JM Fabrics Ltd. (Extension)

11th October 2023

Observations

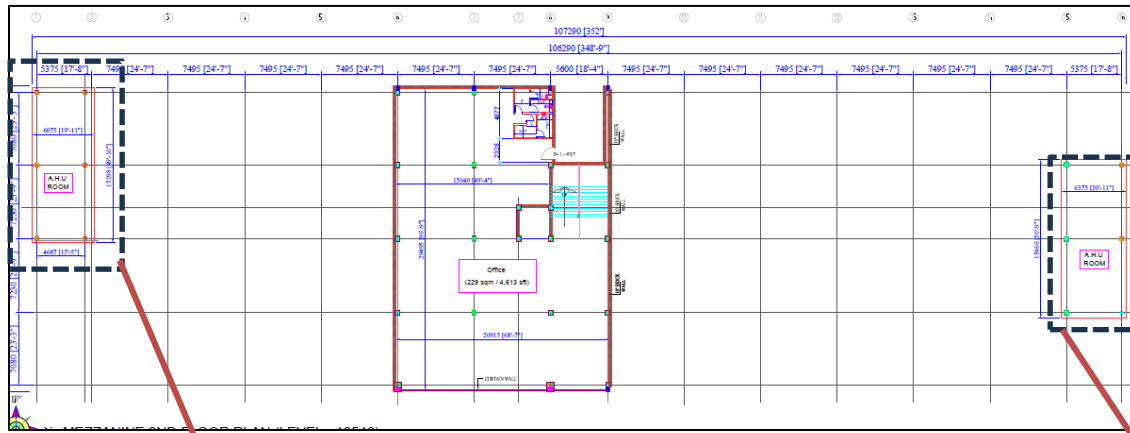
Eccentric bracing was observed in the building. Building engineer is required to incorporate the eccentric bracing in the design.

A.H.U Shed on roof

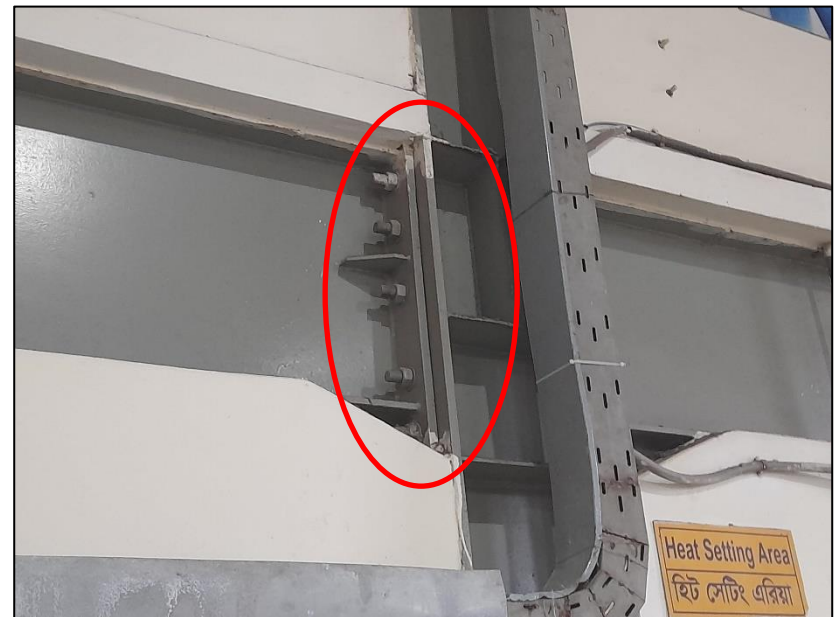
During inspection, two steel shed on roof was observed over the two A.H.U room area. However, no structural details of these 2 sheds were available in structural drawing. Building engineer is required to update as-built drawing incorporating all structural details of this sheds.

Column Schedule

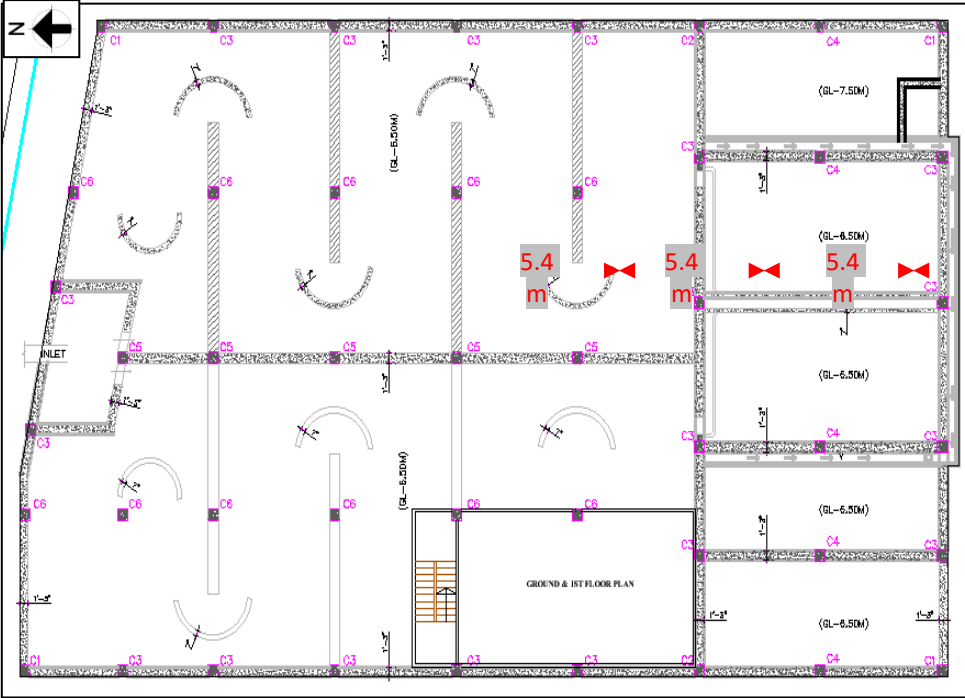
As per the column schedule from the available structural drawing, the dimension of column C6 was shown 20" X 20". However, during the inspection, all C6 columns were measured 15" X 20". Building engineer is required to resurvey the whole structure and update the as-built drawing accordingly.

Lack of Lateral Stability

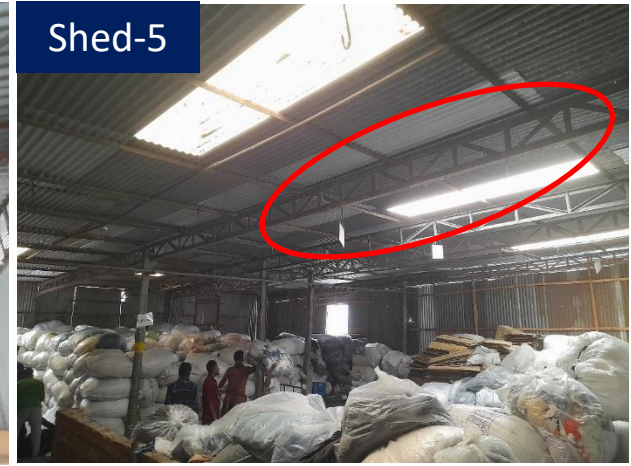
No bracing/Compression strut was provided along the long direction.

Truss frame is provided along short direction. Any compression member along long direction with any lateral bracing was not available. Therefore, lateral stability along long direction is questionable. Building engineer is required to check the lateral stability for Shed-3, Shed-4, Shed-5 & Shed-6.

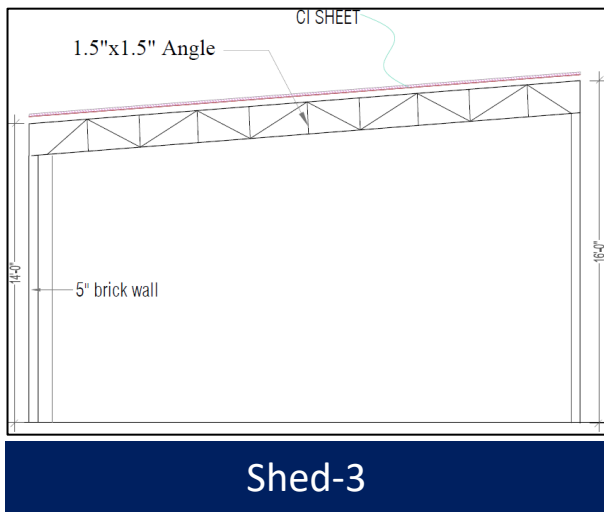
Purlin inserted to brick wall

Truss welded with rebar of RC column

Poorly welded truss with steel pipe

Trusses of Shed-3, Shed-4, Shed-5 & Shed-6 were found arbitrarily welded with rebar of RC column and inserted to brick wall therefore connection of steel members to brick wall and RC columns appeared to be inadequate. The Building engineer is required to check the connection adequacy for uplift forces as part of EA.

Shed-3

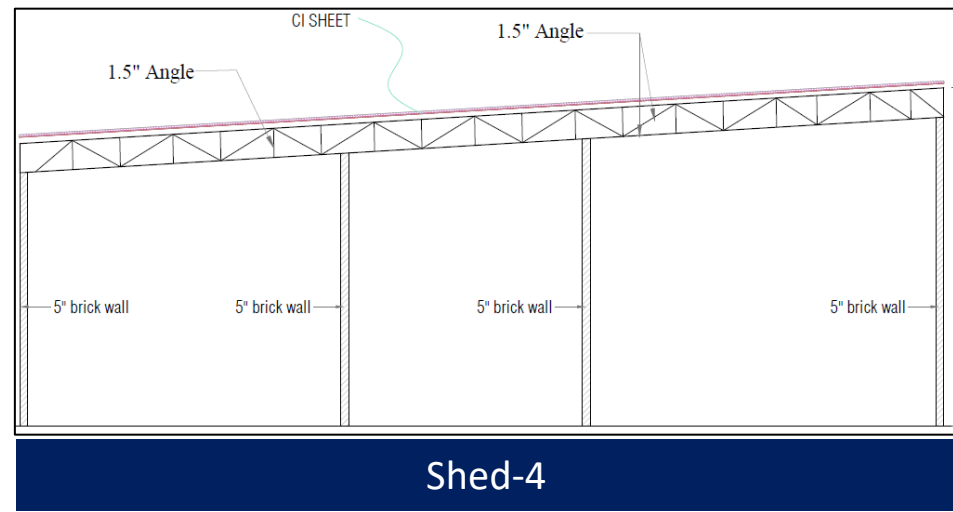
In available structural drawing, structural details like dimension and thickness of steel members for Shed-3, Shed-4, Shed-5 & Shed-6 were not provided. Building engineer is required to resurvey the whole structure and update as-built drawing accordingly.

RC mezzanine structure.

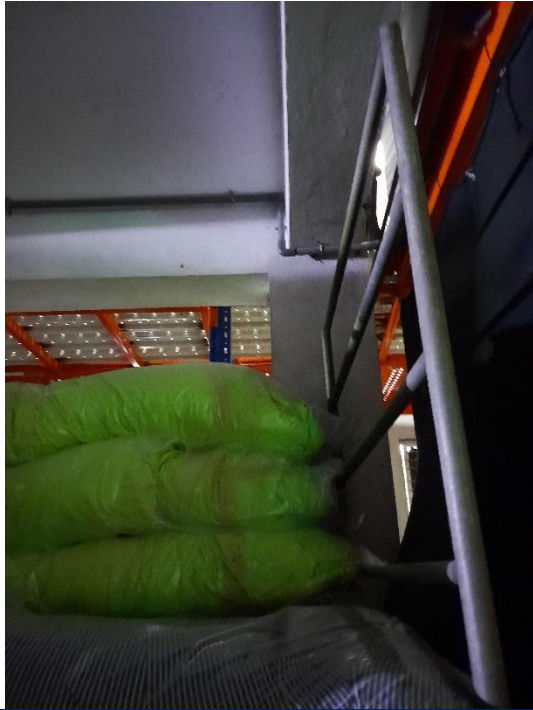
During inspection, a single storied RC mezzanine floor was observed inside Shed-7 which was structurally separated. However, as-built drawing was not available for this structure. Building engineer is required to prepare full set of as-built drawings incorporating all structural details of this structure.
